NUCLEAR REGULATORY COMMISSION

CONSOLIDATED EDISON COMPANY OF
NEW YORK, INC.

(Indian Point Number 2)

Docket No. 50-247

Fig. 4-1 Construction Schedule

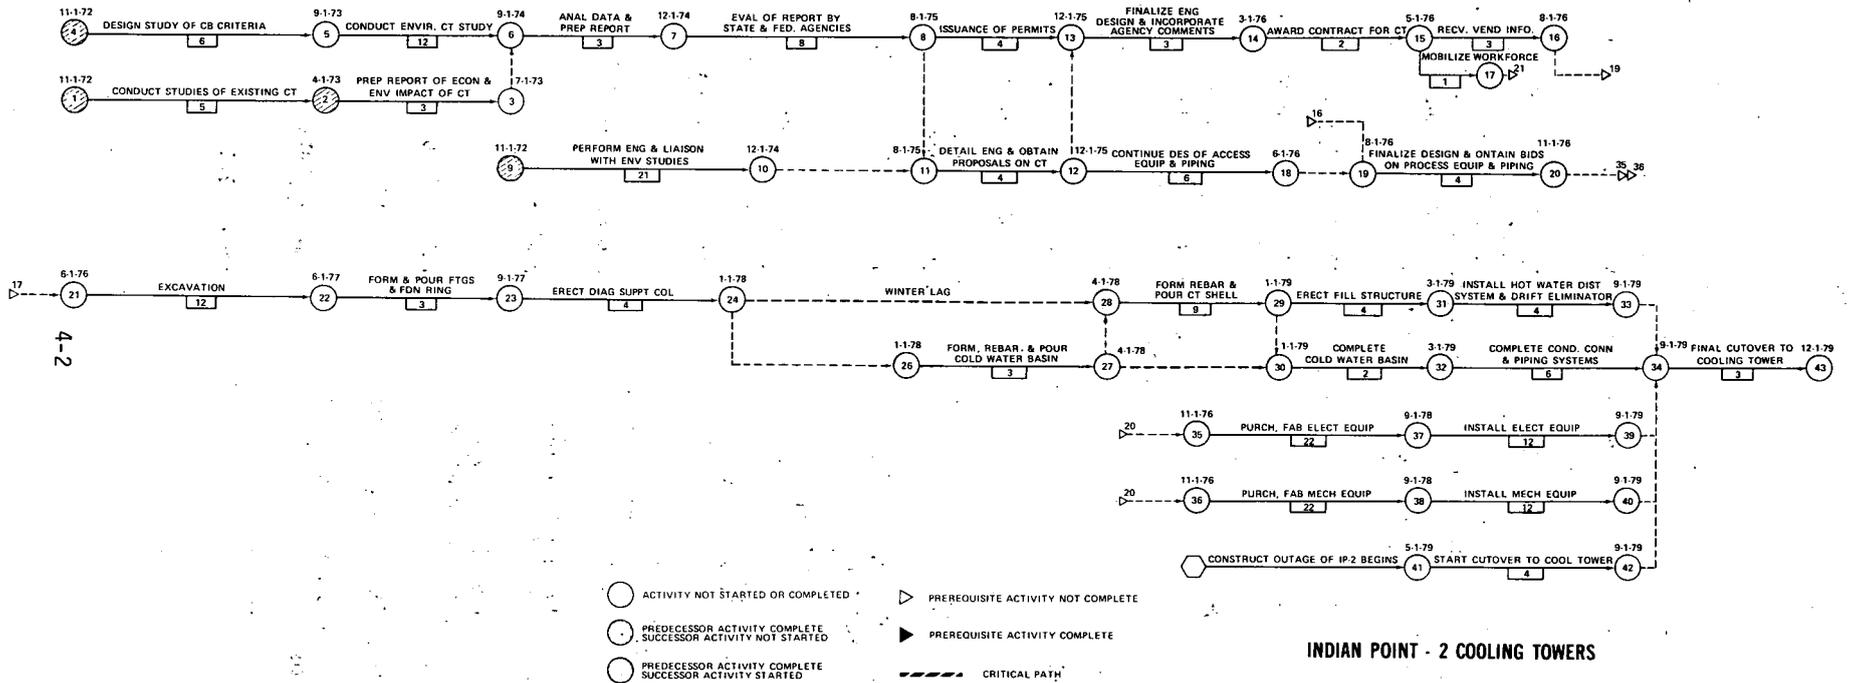
The construction schedule, as originally proposed, is given in Figure 4-1 and was based on completion of NRC and agency evaluation and issuance of permits by December 1, 1975. However, as stated in sections 1.3 and 4.1 a stipulation, signed by the parties to the Indian Point proceedings, provides that the "May 1, 1979" date is subject to acceleration or delay depending on various conditions. Paragraph 2E(1)(b) of the stipulation which is applicable is reproduced below in its entirety.

Figure 5-20

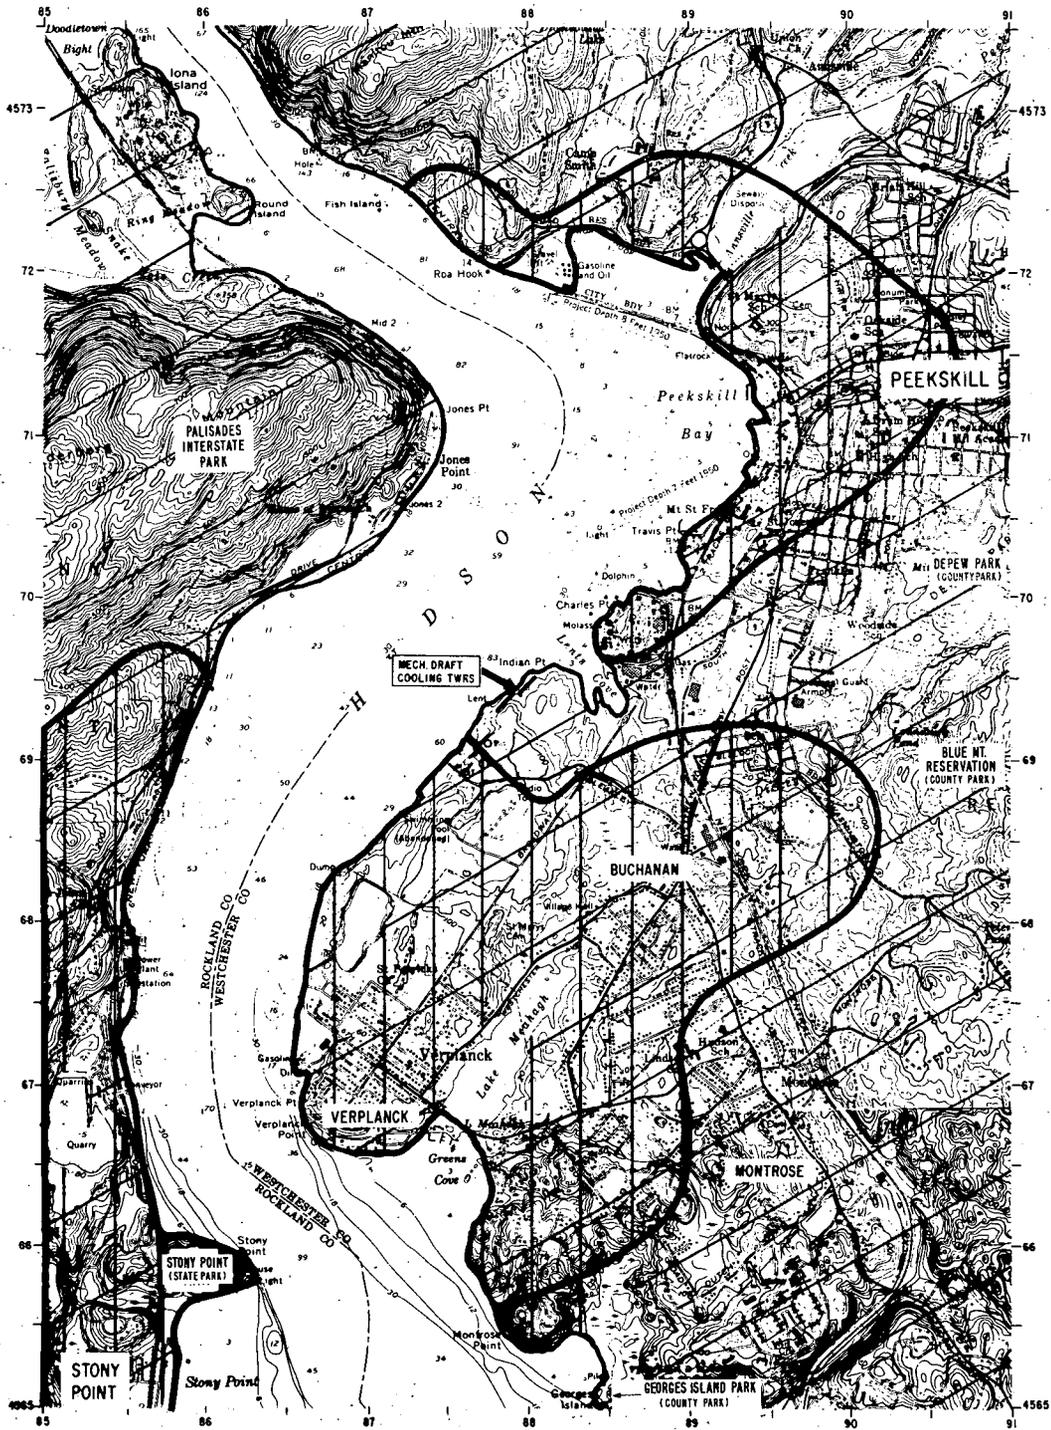
The applicant has prepared a map of potential botanical injury due to NDCT drift based on threshold rates measured in the Boyce Thompson experiments (Figure 6.9 in the applicant's ER-CCC, IP-2 reproduced in this statement as Figure 5-20). Threshold contours on the maps closely follow the 100 and 200 Kg/Km^2 drift contours from the computer model. It was indicated by the applicant, however, that threshold values were selected from experimental results which were obtained at a humidity which would maximize injury (85%). This is probably unnecessarily conservative since most ambient humidities fall in the range of 50% to 90% where salt effects are at least a factor of two less than the maximum.

Allowing for a factor of two as an overestimate of potential damage, the drift contours of damage compress to include only the area enclosed by the 200 Kg/Km^2 (1.8 lbs/acre) contour of Figure 5-1. Considering further the low probability having 14 rainless days, the ability of vegetation to survive foliar injury and partial defoliation, and the probable conservative thresholds established by the chamber experiments, the staff believes it is likely that no permanent damage to vegetation will occur due to saline drift from a natural draft cooling tower. Symptoms of foliar salt burn could occur occasionally within the 200 Kg/Km^2 contour in some years.
